Standardized Information for Process/Product Change Notification (PCN)

1. PCN basic data		
1.1 Company		
1.2 PCN No.	PCN17009-1	
1.3 Title of PCN	A new fully-automated SMB backend assembly line transfer	
1.4 Product Category	Active Components - Discrete Components ▼	
1.5 Issue date	2019/02/25	
1.6 PCN revision history (optional)	1.7 Issue date of previous revision (optional)	1.8 Delta to previous revision (optional)
PCN17009	2017/02/07	A new fully-automated SMB backend assembly line transfer

PCN17009-1 Comparison Report

Subject PCN NO: PCN17009-1
Automotive SMB Comparison Report

Processes Comparison---fully-automated SMD vs manual SMD processes

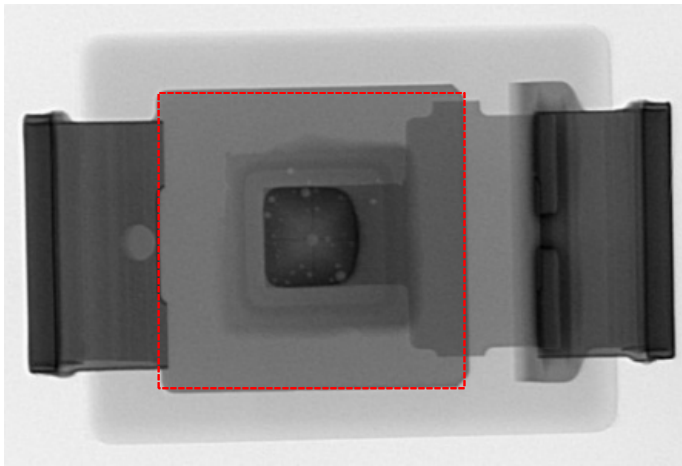
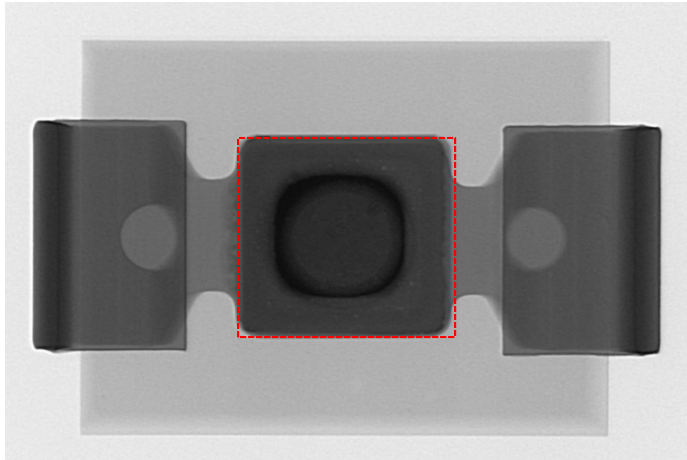
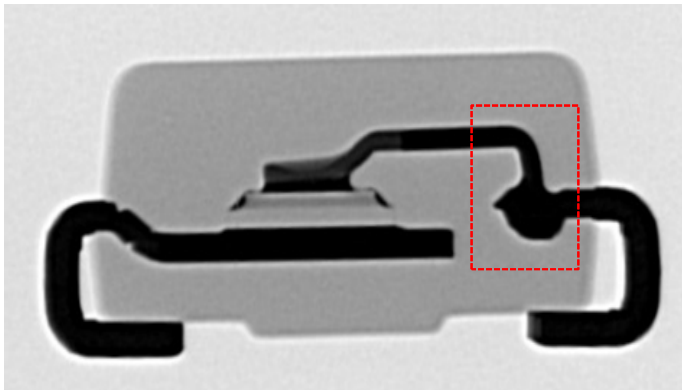
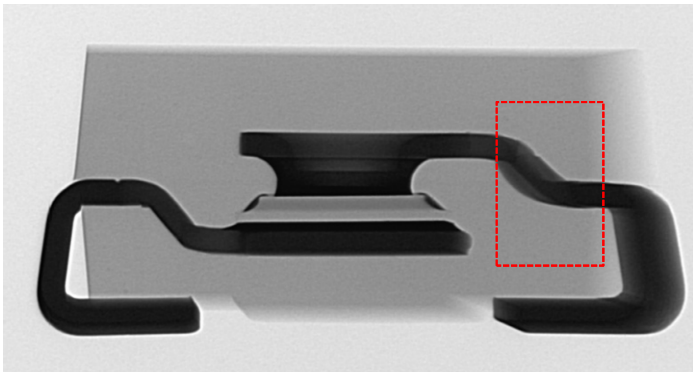
No	Item	Before	After	Remark
1	Processes	manual SMB production line	fully-automated SMB production line	Refer the attached 1.Processes Comparison
2	General appearance	Follow D/S POD refer to the attached	Follow D/S POD refer to the attached	Refer the attached 2.SMB Appearance
3	Package Outline	Follow D/S Spec.  unit: mm Dimensions: (A typ.) 2.00, (B typ.) 4.50, (C typ.) 3.60, (D typ.) 2.35, (E typ.) 1.15, (F typ.) 5.13, (H typ.) 0.20, (G typ.) 0.15, 5°	Follow D/S Spec.  unit: mm Dimensions: (A typ.) 2.00, (B typ.) 4.40, (C typ.) 3.50, (D typ.) 2.10, (E typ.) 1.14, (F typ.) 5.30, (H typ.) 0.20, (G typ.) 0.15, 7°	
4	Lead Frame	Supplier : A Material : Copper 	Supplier : B Material : Copper 	
5	Molding Compound	Automotive (Non-HF) Type: EME-66XX series Supplier : A Material : Epoxy Automotive (HF) Type: EME-E110 Supplier : B Material : Epoxy	Automotive (Non-HF) Type: EME-66XX series Supplier : A Material : Epoxy Automotive (HF) Type: EME-E500 Supplier : B Material : Epoxy

Appearance Comparison---fully-automated SMB & SMB

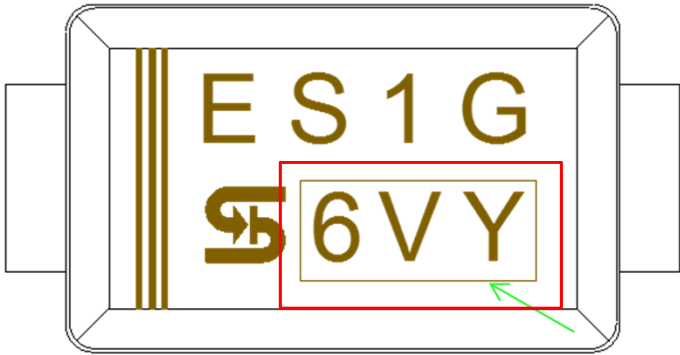
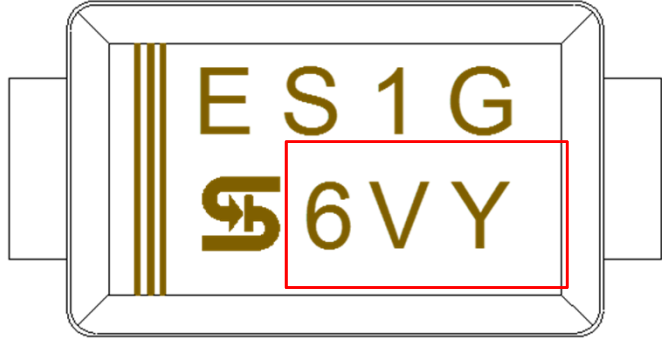
Uniform forming designed

X-RAY Comparison----- example SMB

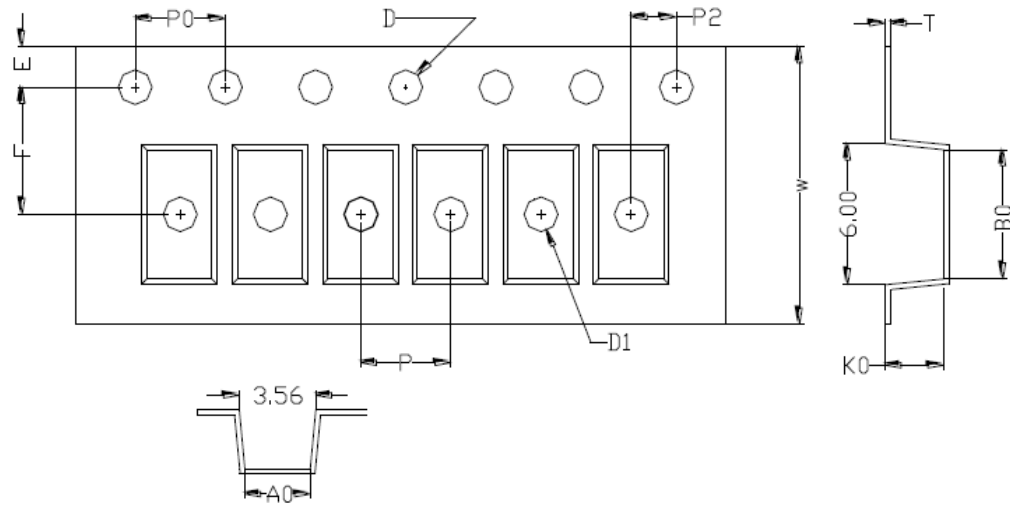
Big die solder pad designed for better thermal dissipation.

Additional solder join between Leadframe and clip reduce soldering thermal stress from wave soldering.

Extension temperature cycle from 1000cyc. To 3000cyc.
